Work Session: City Hall Update

Eugene City Hall – Phase 1

Summary of Initial Cost Reduction Strategies for City Hall

2016-09-01
COST REDUCTION
STRATEGIES

FIRE SPRINKLER
CONCEPTUAL
LAYOUT

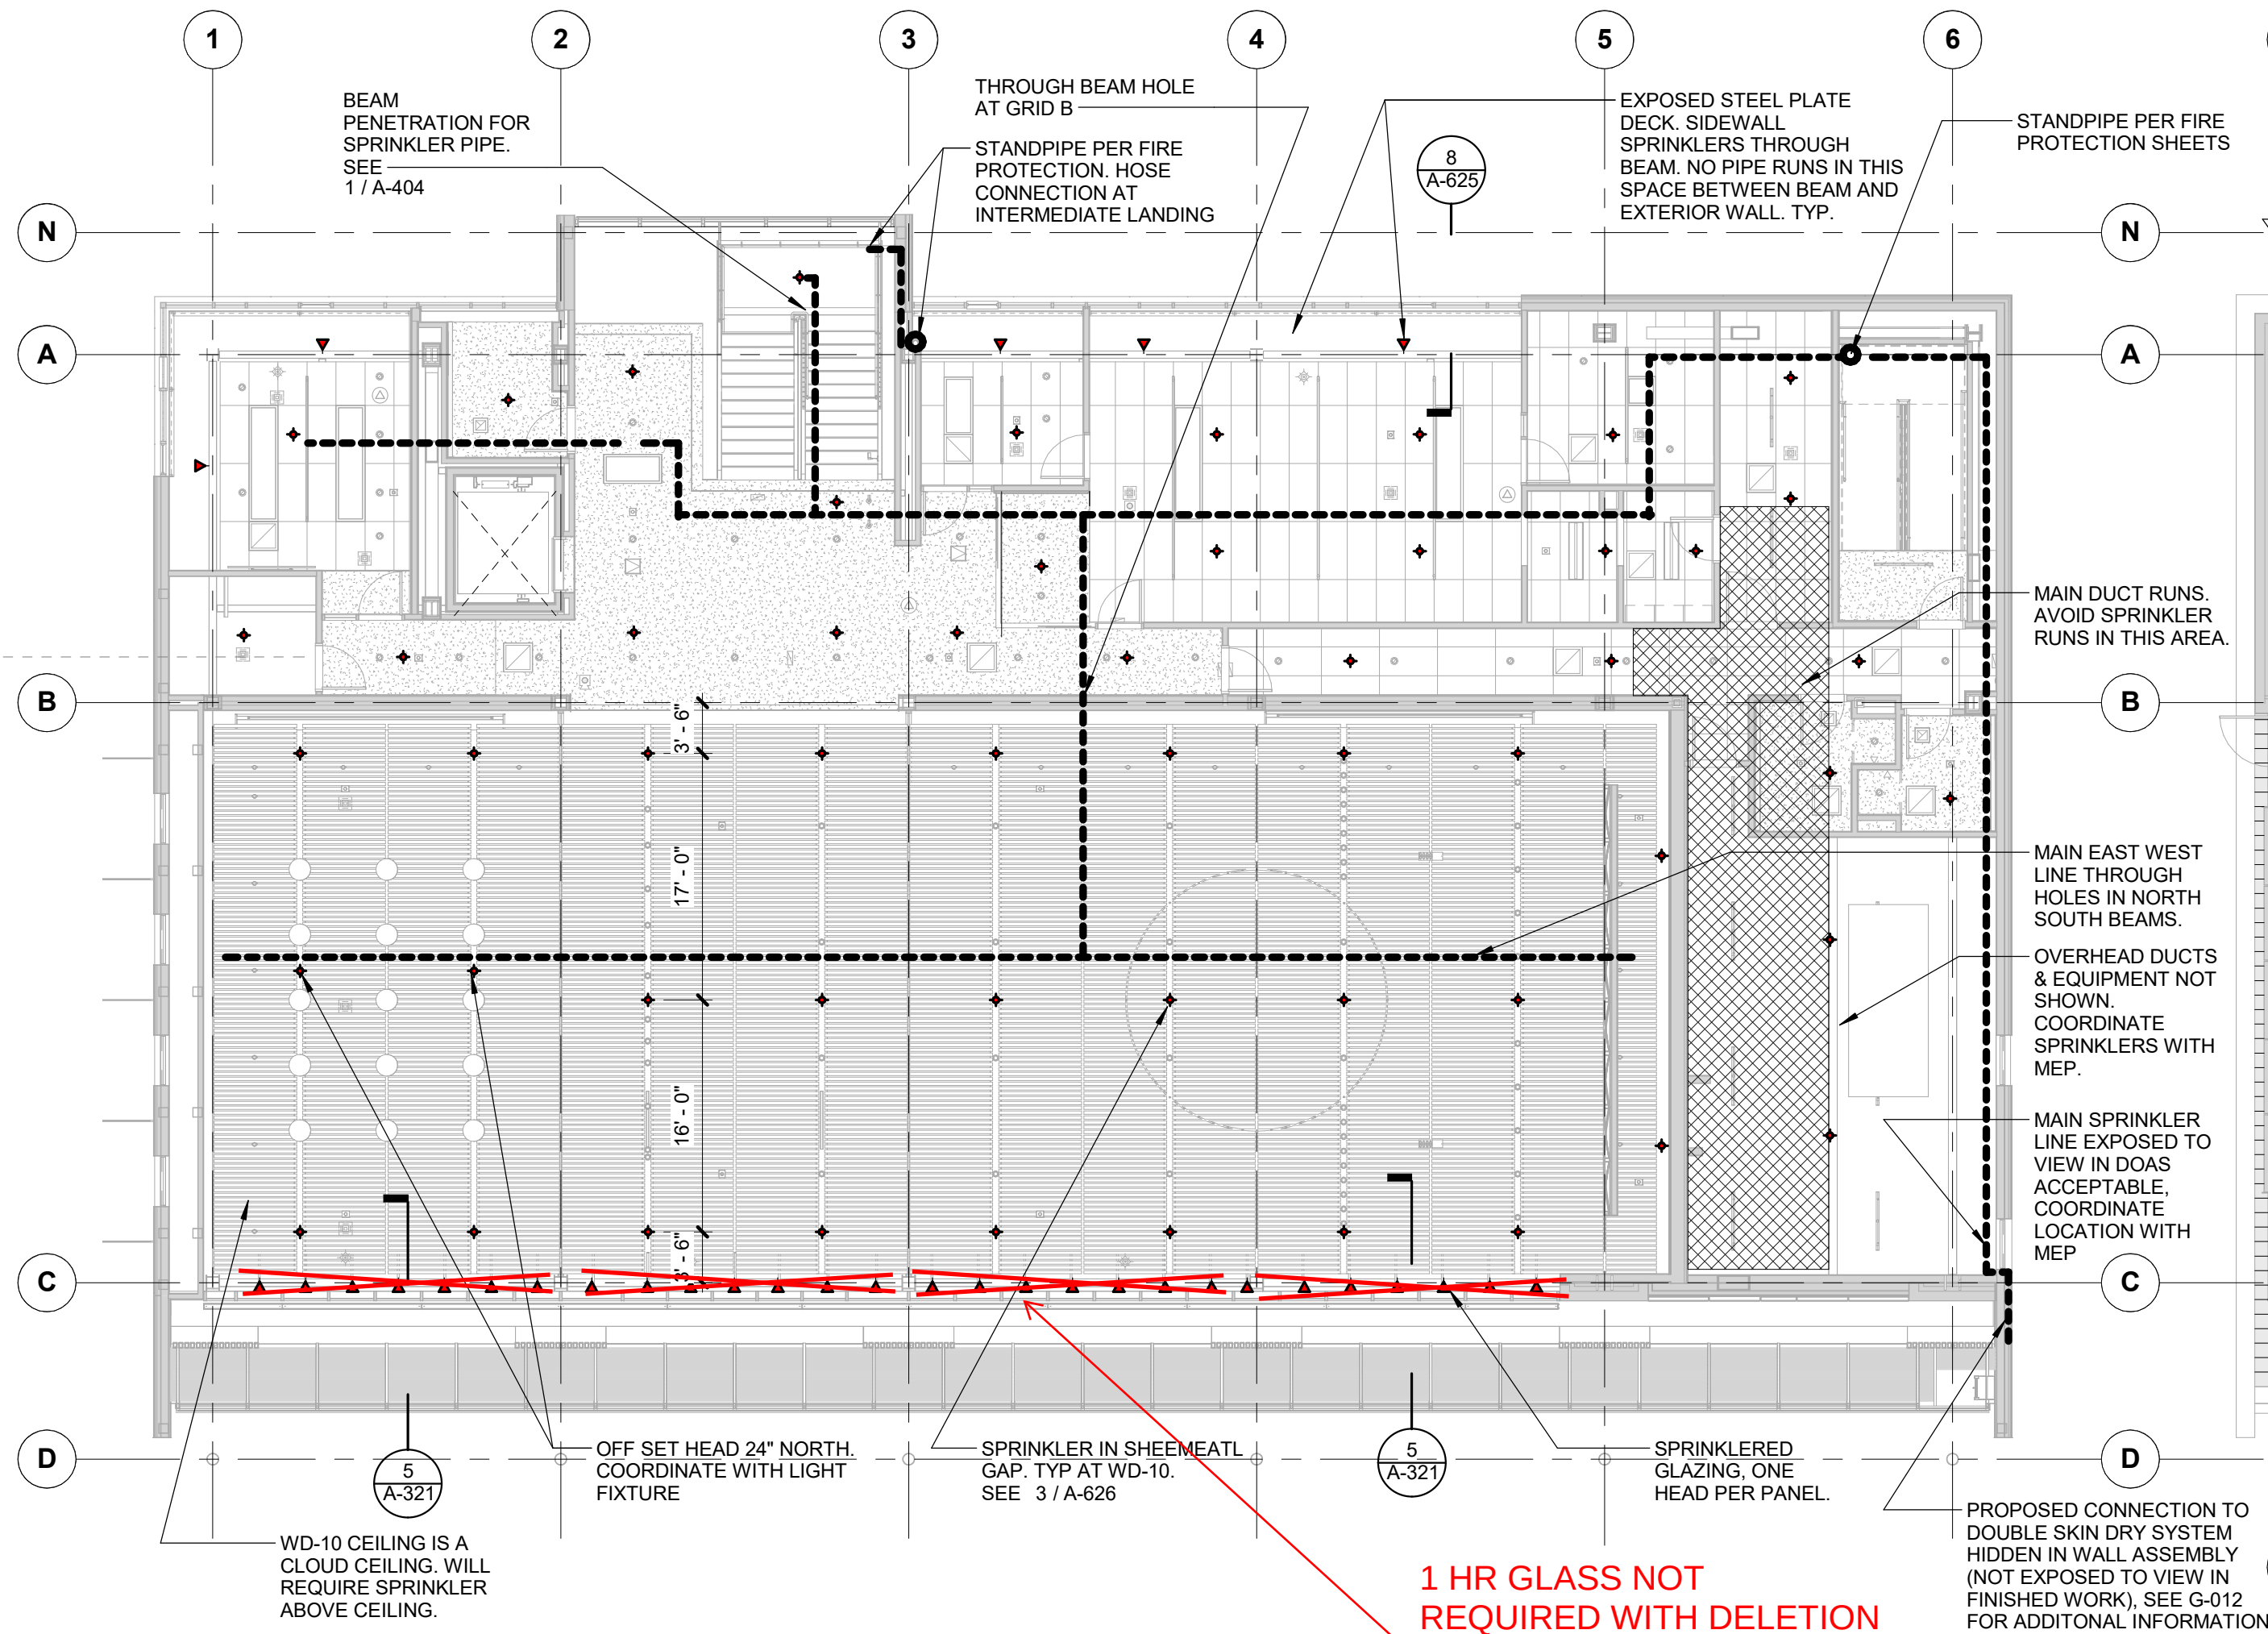
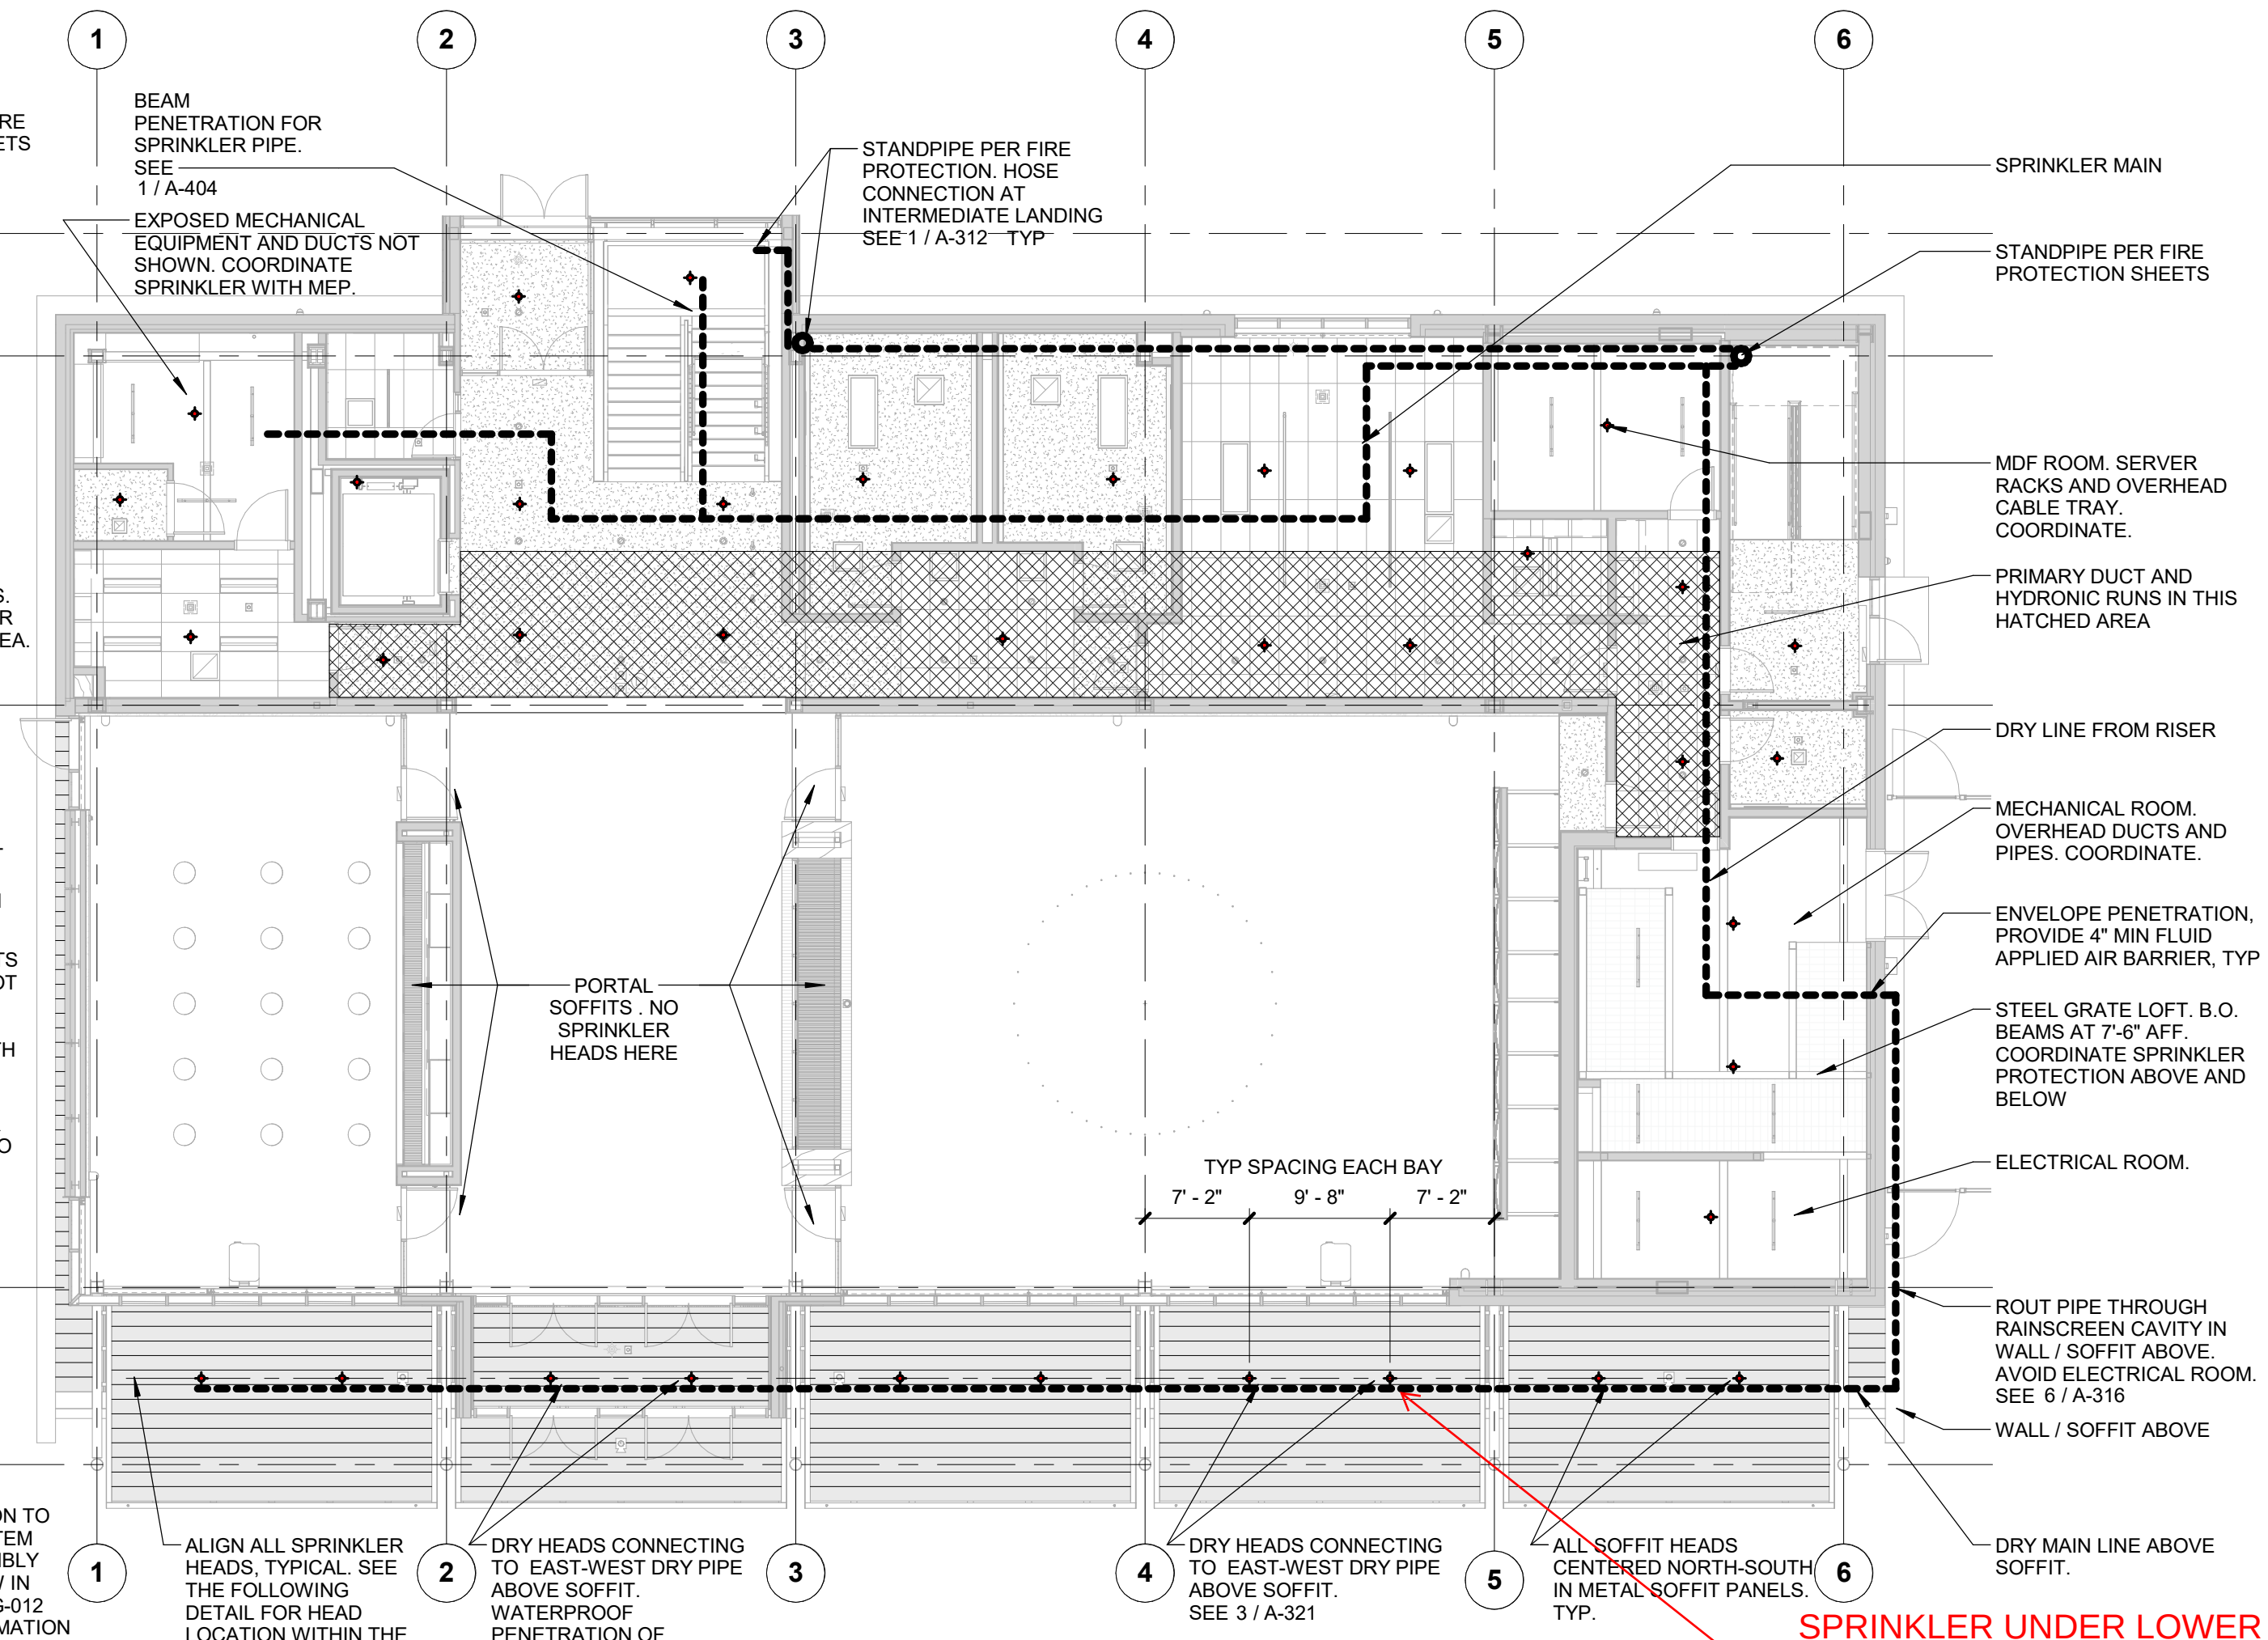
NOTED SPRINKLER DELETIONS
ARE POSSIBLE IF THE DOUBLE
SKIN IS DELETED. DELETION
OF THE DOUBLE SKIN IS NOT
DIAGRAMMED ON THIS SHEET.
